# UNITED STATES PATENT AND TRADEMARK OFFICE

APPLICATION NO.	FILING DATE	FIRST NAMED INVENTOR	ATTORNEY DOCKET NO.	CONFIRMATION NO.
10/581,794	05/15/2007	Konrad Eipper	095309.57762US	8655

<b>Office Action Summary</b>	<b>Application No.</b> 10/581,794	<b>Applicant(s)</b> EIPPER, KONRAD	
	<b>Examiner</b> ERNESTO GARCIA	<b>Art Unit</b> 3679

## DETAILED ACTION

Fig-2

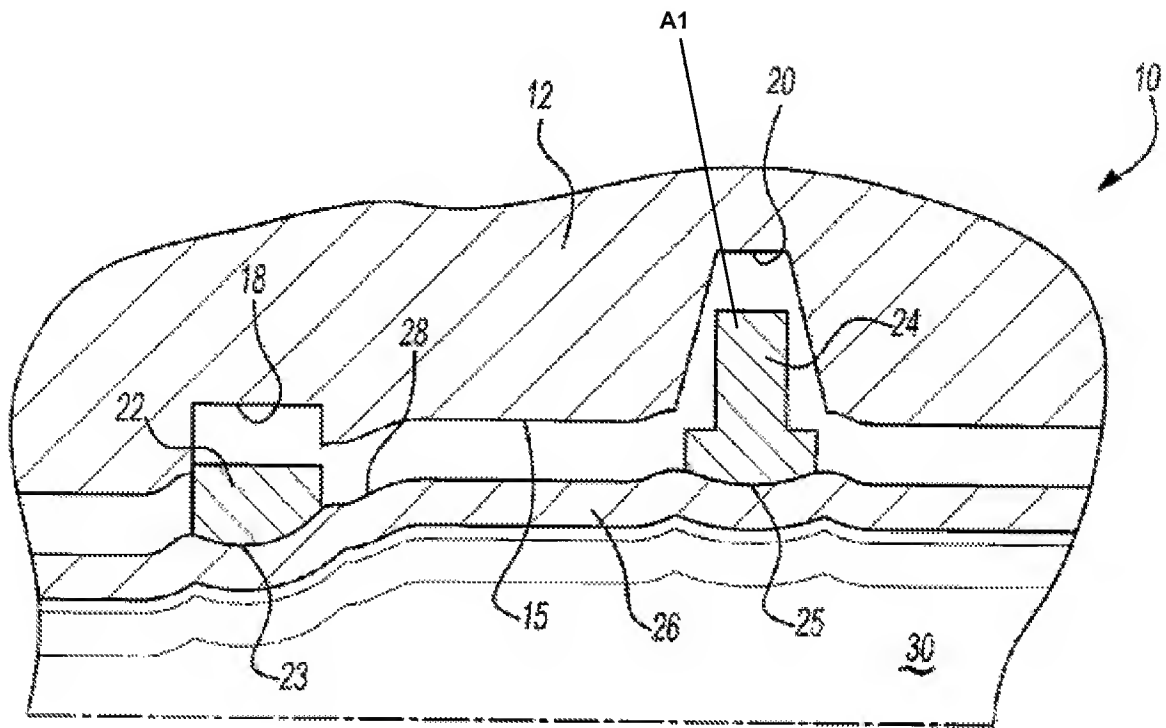
Regarding claim 13, Varela discloses, in Figure 2, a hollow profile joint comprising a hollow profile **28**, a joint part **24**, and an adhesive [016]. The hollow profile **28** is located in a through-opening of the joint part **24** at a joint point. The hollow profile **28** is expanded at least at the joint point and adjacent to the joint part such that an annular bead-shaped step, formed on the hollow profile **28**, bears against the joint part and the adhesive is located between an inner side of the joint part **24** and an outer side of the hollow profile **28** at the joint point.

Regarding claim 14, a fastening section **A1** (see marked-up attachment) is arranged on the joint part **24**. Note that the fastening section **A1** can permit fastening of the joint part and the hollow profile to another component.
